RANCHO SECO UNIT 1
TECHNICAL SPECIFICATIONS

Figure 6.6-2
 PLANT ORGANIZATION CHART
 Proposed Amendment 67

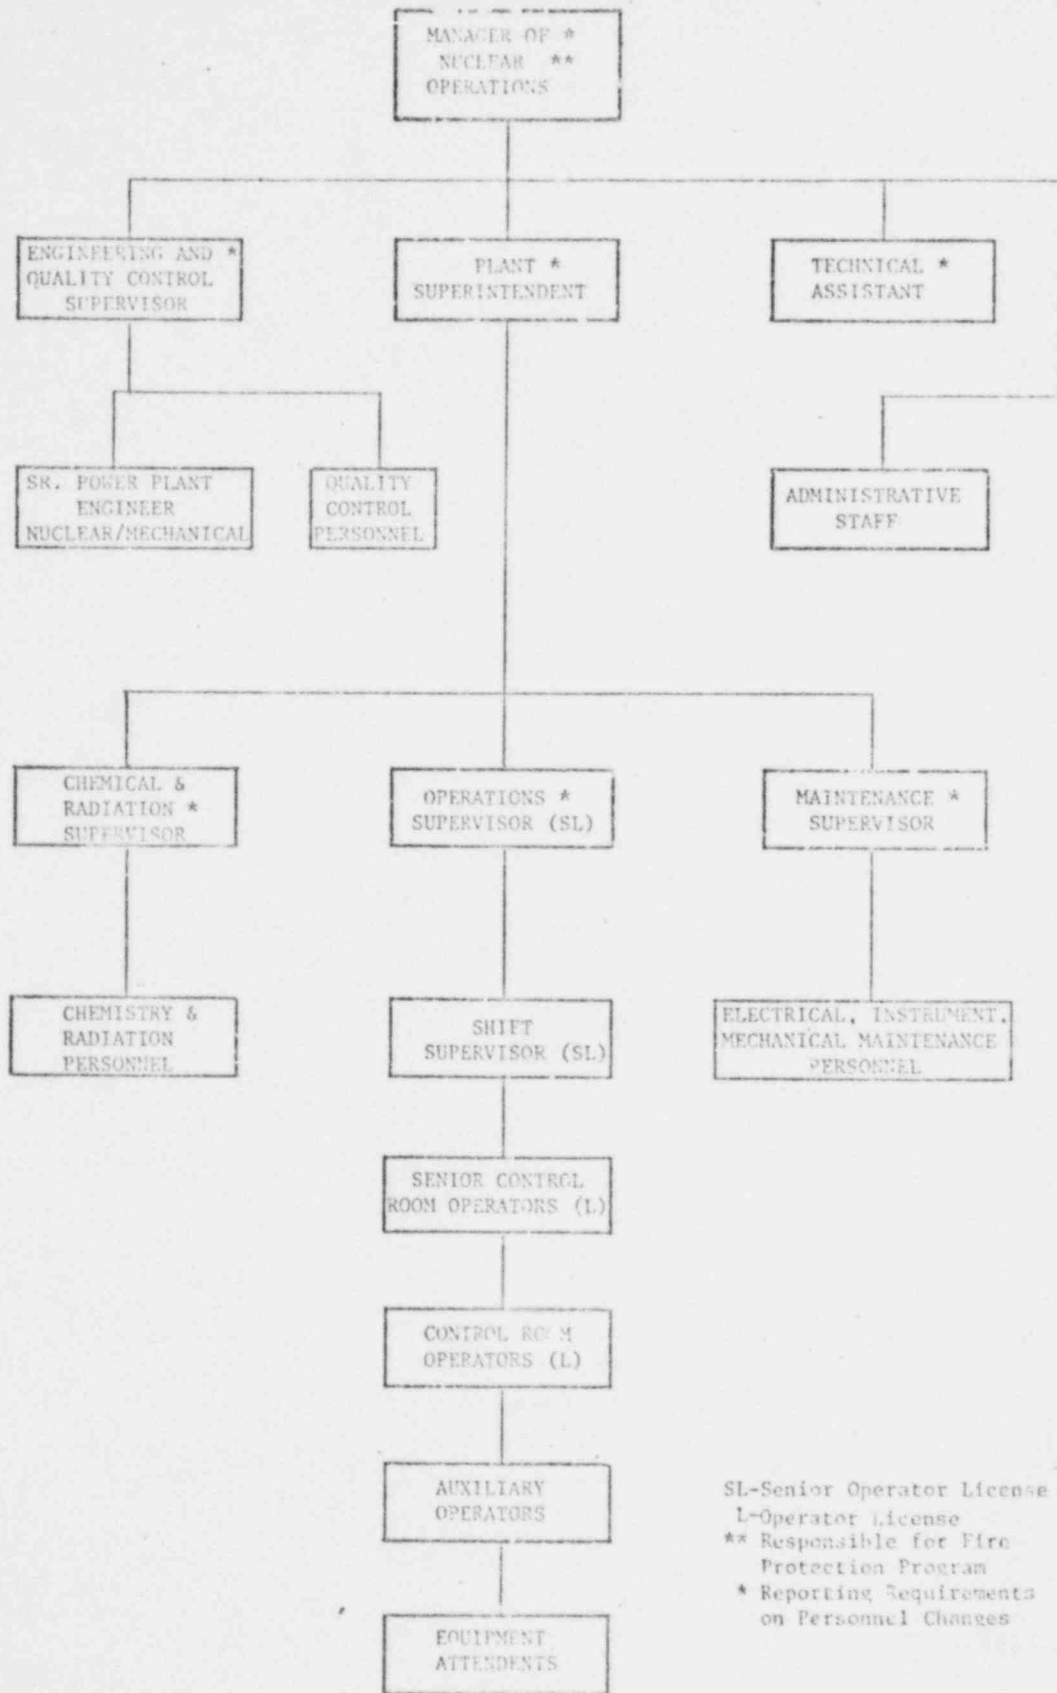
SL-Senior Operator License
 L-Operator License
 ** Responsible for Fire Protection Program
 * Reporting Requirements on Personnel Changes
